LAZY 5 VIRTUAL WORKSHOP/WORKSHOP #2

Date: Tuesday, September 29 2026, 6 p.m. - 7 p.m. | Thursday, October 1 2026, 5 p.m. - 7 p.m.
Location: Lazy 5 Regional Park – 7100 Pyramid Way, Sparks, NV 89436

CONCEPT 1

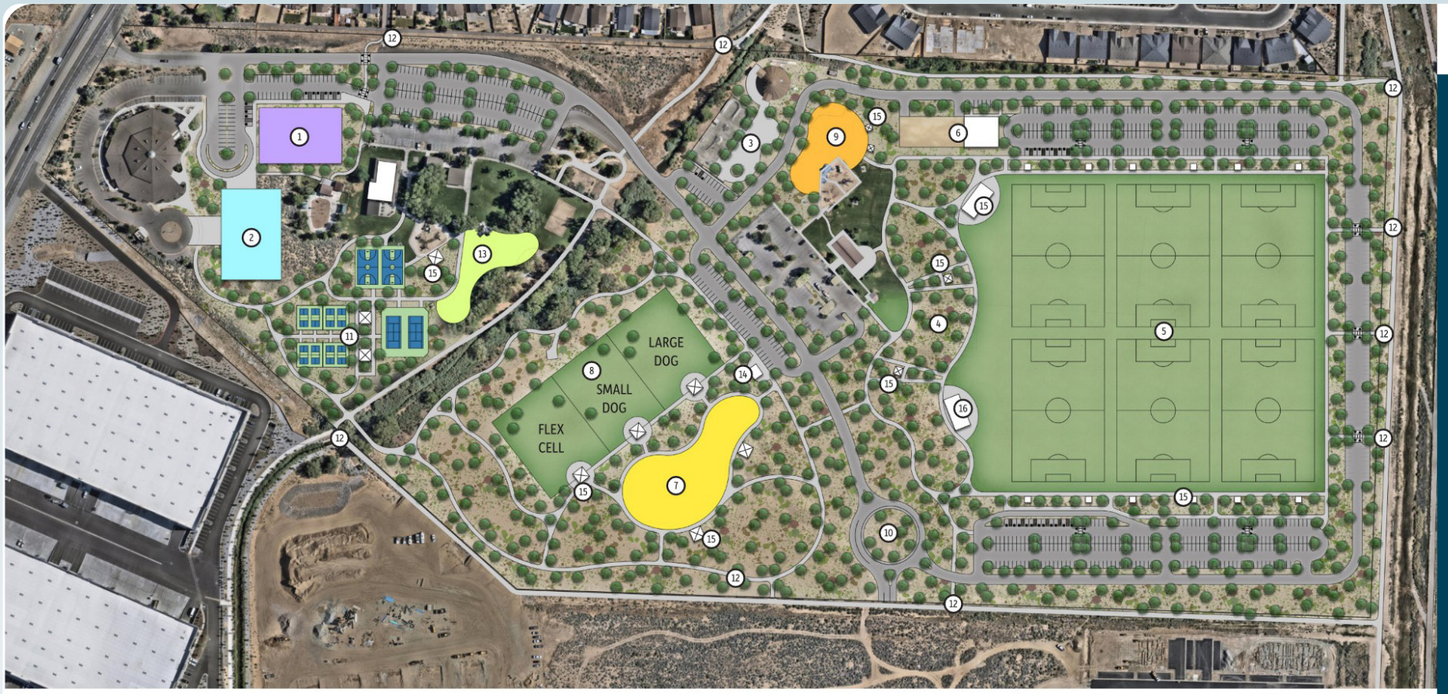
What do you like about this concept?

- Walk path is nice buffer area.
- Rec/Aquatics center;Multi-use field
- Soccer field placement; Parking through middle; flow is good; rec & Aquatic plan is good; like all the trails/ nature & linking to trails.

- Combo rec/aqua center
- Look less costly except Aquatic center/gym.
- Good layout roads; position of park
- Rec center by hive; dogs away from kids; trail to playground

- Like the huge nature play zone; rec. center.
- It keeps the parking lot away from residential area.
- Aquatics center! Yea!; Aquatics & rec center combined! Good you can omit picnic pavillions and put in the restrooms needed for multi-use fields.

- This is the best for me and my family. I am concerned about proximity to soccer fields as it is very noisey where I live. I am on Evangeline and back up to the park.

- 1) Access to park facilities must be improved! 2) Year-round drinking faucets for pets 3) Contour dog park areas to provide excellent drainage 4) Utilize the existing drainage facilities along the southern bounpry of the area used as a dog park now 5) provide restrooms for dog park patrons

- Overall good plan but- Nicole will be uploading a revised plan- please see her plan

What could be improved?

- More restrooms- not a port-a-potty!!
- Parking, esp. by aquatic center; 50M pool instead of 25 yard to help w/future growth
- Area for indoor rec center and pool is shortsighted should be bigger to better serve the community. More parking

- Parking issues between fields and dog park; Need park access from north; Need senior center/indoor pool for water aerobics
- Seems financially impossible; All the concepts need improvements to pickelball, outdoor or revamp the hive. Shade for outdoor courts.

- In & out access
- Swap dog park to where it is in concept 2; move nature area to where dog park is; include stage in lower park; Include some tennnis, b-ball & pickleball courts from concept 2

- Move the pump track from the dog area; another restroom
- Parking closer to concert area; more restrooms; less pumptrack; more access from north and west.

- Move to concept 2 (Dog park)
- Pump park by/ with skate park; more bathrooms; nature play zone biggerPerferably less foot traffic by residential areas and block off or build taller fencing for privacy for residential homeowners; add the courts to this concept; roundabout a little pointless.

- Add higher barriers to fence off the area to keep fot traffic away from residential area on particular by #5 and # 9. Add more amenities in the area below #1. Less grass by soccer field & make it a buffer between residential area.

- Numbers transpose the multi-use fields away from homes and no landscape on a low speed roundabout or around the roundabout and maintain the 2nd exit. Broaden second exit near the industrial stuff. Still needs protected L&R turns. I already avoid the spanish springs library for the traffic reasons. To not address this above immediatley ignores basic need.

- Please keep parking away from residential and soccer parents and players far from the fence line- I like the trails and dog park!!!
- Flip dog park and expand to more than 3 acres total to combine large, small park into lakes, move play area to where showing dog park. Too many folks throwing balls in lake, dogs could crush; Don't want to see any cement with sement tables in dog parks- tables away from play areas- Trees with a bunch would be great. The dogs need a good unstructured area to run- Expand dog park to 40 acres would be a great amount of space.

CONCEPT 2

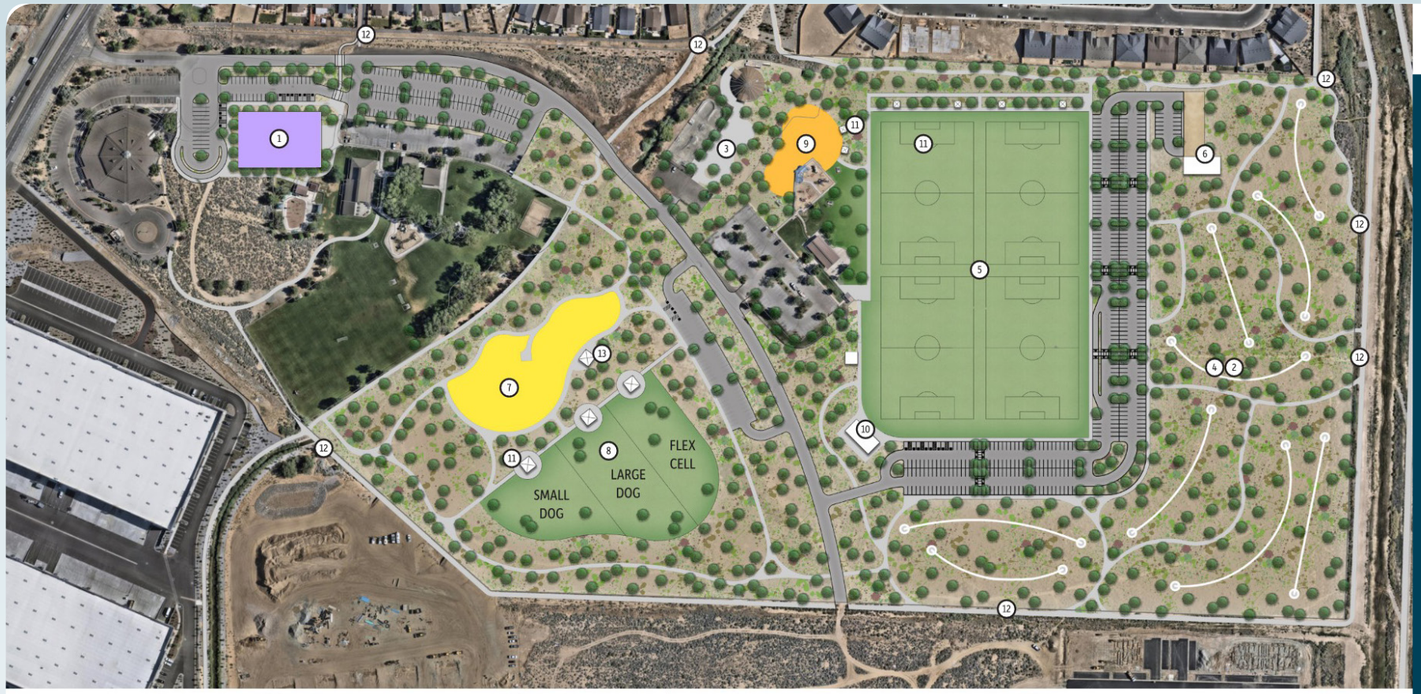
What could be improved?

- Don't move music stages. Not a port-a-potty
- Courts should be inside to use in winter; Could take pool/gym from concept #1 & put on #2; longer pool (50m) for long term growth, smim meets bring $; Larger rec. center

- Courts should be inside to use in winter; Could take pool/gym from concept #1 & put on #2; longer pool (50m) for long term growth, smim meets bring $; Larger rec. center

- Need access from north; Senior cenetr w/pool indoor for water aerobics
- Combine the rec/aquatic building
- Pickelball needs a refresh inside the hive as well as outside the courts

- Better in & out access
- Do not like the parking all around the fields; too many fields; no nature area included; not enough multi-use trails
- Pump track-skate park in the same area not next to a dog park.;More restrooms.

- hate the parking and road by evangeline; don't put maintenenace bldg right behind my house.
- Parking closer to concert venues so that handicap & non-ambulatory attendees don't have to push wheel chairs and walkers so far; more restrooms; less pumptrack; more access from north and west.

- Nature play in nature and rec center; more play areas; dogs away from pump
- Hate the new road and parking by the toll brothers residential area. Please add a buffer between houses and fields/activities. (less foot traffic and car traffic please); Add privacy fencing for residential homes.

- Shifting #5 higher to keep parking lots away from residential areas. Eliminate parking lots above #5.
- Lessen and move pump track towards the outdoor tennis. Move dog park towards the industrial side. Double restroom size and move it toward the ORR ditch. Put a smaller restroom/ or even a changing room out by the maintenence yard. Reduced this much parking by 10% or so. Idea! Put picnic areas in a curvy "strip" near the basketball/tennis and give them a seasonal pinch for non-freeze months, if there is really support of icnic areas. Somehow I think of B-day parties at commercial areas. It makes me think maybe picnic areas are an overvalued feature unless there is a drastic change.

- Switch pump and dog park closer with nature trail; remove pump to close to dogs; disc park takes up too much space.

What do you like about this concept?

- Extra parking all over.
- Lots of parking
- Parking; added fields; keeping dog park area in a separate spot from fields
- Parking for dog park away from fields is better; additional fields
- Location of dog park
- Like the new outdoor courts, bathroom access to thos is poor on the concept though
- Multi-use fields with stage; Rec& Aquatics center; Tennis/ Pickleball/Basketball Courts; Lots of parking
- Dog park location & trails; Stage in lower park; outdoor courts for tennis pickleball & B-ball
- indoor facility; more picnic pavillions
- Soccer field location; love where the soccer fields are on 2
- Look relatively less costly except aquatic center
- Definitely like the variety of activities (courts); Rec. center
- The variety of amenities
- Can you join Aquatics and rec center somehow? It can save some space. Low shrubs only on a roundabout.
- like dog park - pump but switch
